AIRCRAFT ENGINES

SERVICE INSTRUCTION

CHANGE OF THE EXHAUST GASKET ON ROTAX® ENGINE TYPE 582 UL, MODEL 90/99 AND ON ROTAX® ENGINE TYPE 618 UL SI-2ST-002

Fig. 1

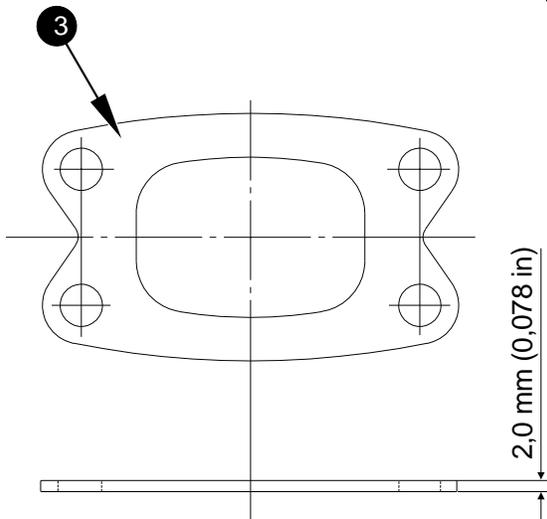
- Verify alignment of the cylinders by use of the listed alignment tool (1) or with the original exhaust manifold and check with a feeler gauge (2). At a gap on the mating face in excess (of max. 0,3 mm/0,012 in) reset the cylinders (see fig. 1).

Fig. 2

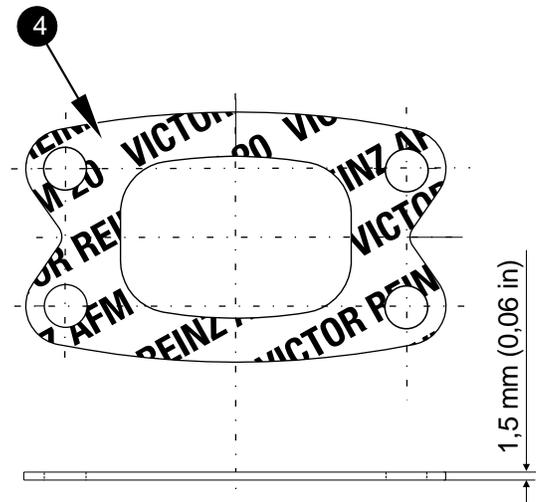
▲ **WARNING:** Fit either only old or only new type exhaust gaskets but never mix old and new gaskets as they are of different thickness (see fig. 3 and 4).

Exhaust gasket
OLD version
Part no. 850.630

Exhaust gasket
NEW version
Part no. 850.633

◆ **NOTE:** Fit the new exhaust gaskets (4,6) with the printed side towards exhaust manifold.

- Attach the new exhaust gaskets (4,6) and exhaust manifold with the six Allen screws M8x30 (582 UL mod. 90/99) or with eight Allen screws M6x25 (618 UL) along with new lock washers.

- Tighten the 6 screws M8x30 (582 UL mod. 90/99) crosswise to 22 Nm or 195 lb.in.

Fig. 3

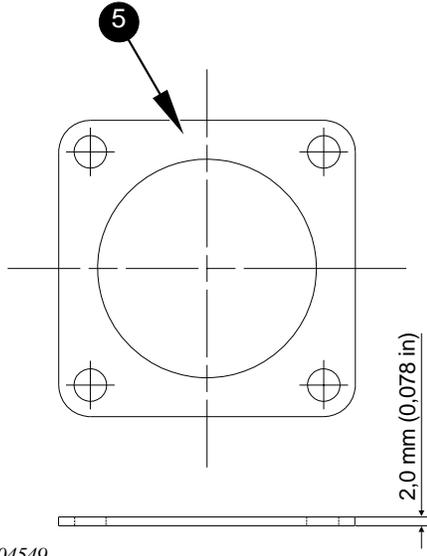
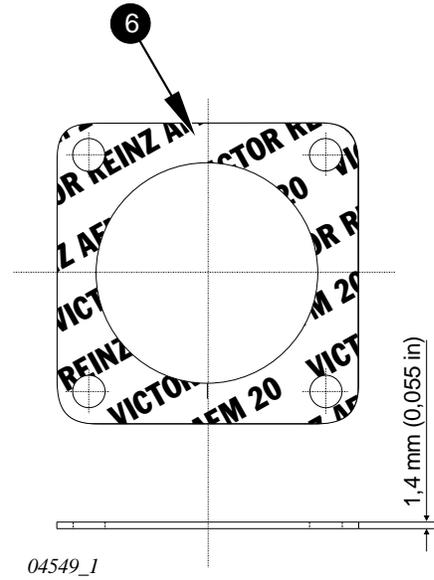
Exhaust gasket
OLD version
Part no. 850.550

Exhaust gasket
NEW version
Part no. 850.552

- Tighten the 8 screws M6x25 (618 UL) crosswise to 10 Nm or 90 lb.in.
